INVITATION TO BID NO: 2219225      ADDENDUM NO: 01

INVITATION TO BID ADDENDUM

FOR:      PARKING LOT & DRIVE RESURFACING/AUT

THE FOLLOWING CHANGES ARE HEREBY ADDED TO AND MADE A PART OF  
(INVITATION TO BID NUMBER 2219225    )

Dept of Youth Services  
Entrance  
Areas to be Widened 6'

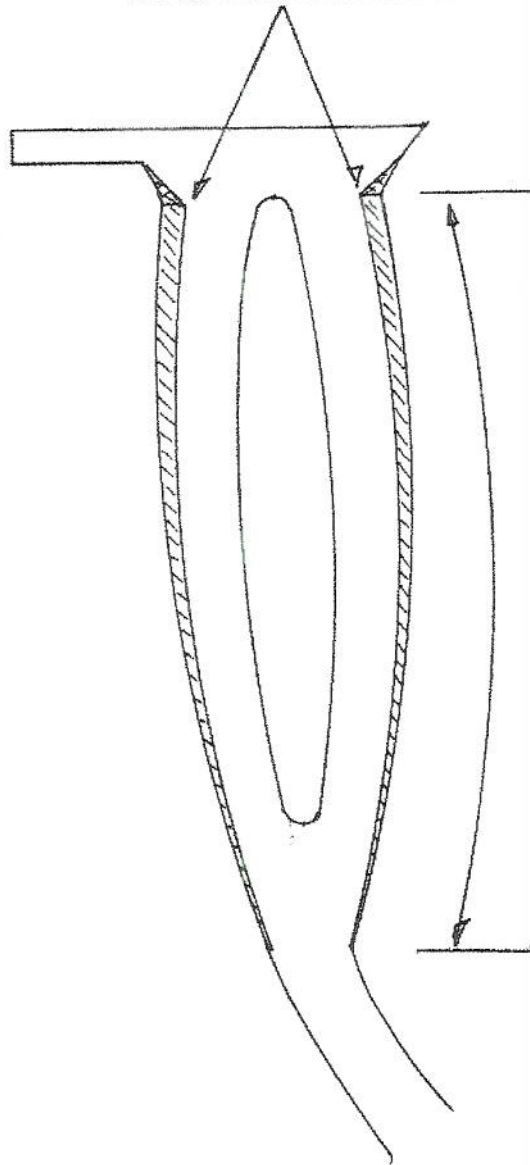
1. Change length on widen both sides of entrance to approximately 350'  
See Drawing 1
2. Add Truck Turnaround Area, 25'x35', Approximately 875 Sq Ft  
See Drawing 2
3. Add Dumpster Approach Area, Approximately 220 Sq Ft  
See Drawing 3

Approximately  
350'

This would add  
Approximately 52 sy  
or 468 sf

# Track Turnaround Area

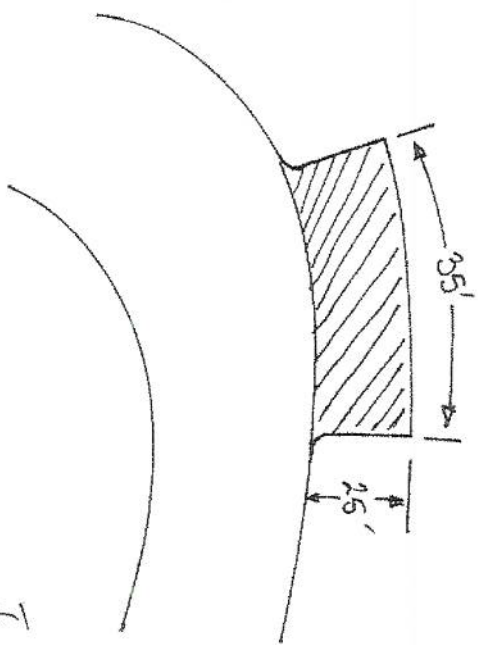
This would add  
Approximately 98 sr  
or 875 sf

I would recommend the same  
building in this area as that  
to be used on the widening in  
the entrance.

# Dumpster Approach Area

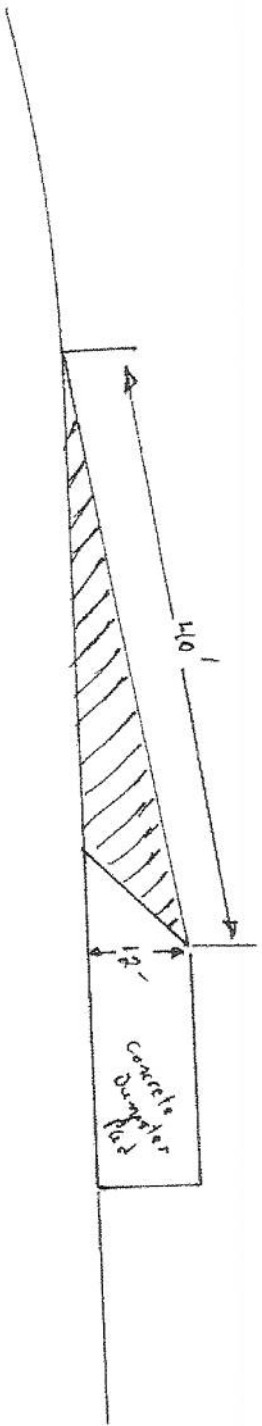
This would add  
Approximately 27 sq  
or 240 sf

I would recommend the  
same buildup in this area  
as that to be used on the  
widening in the entrance.
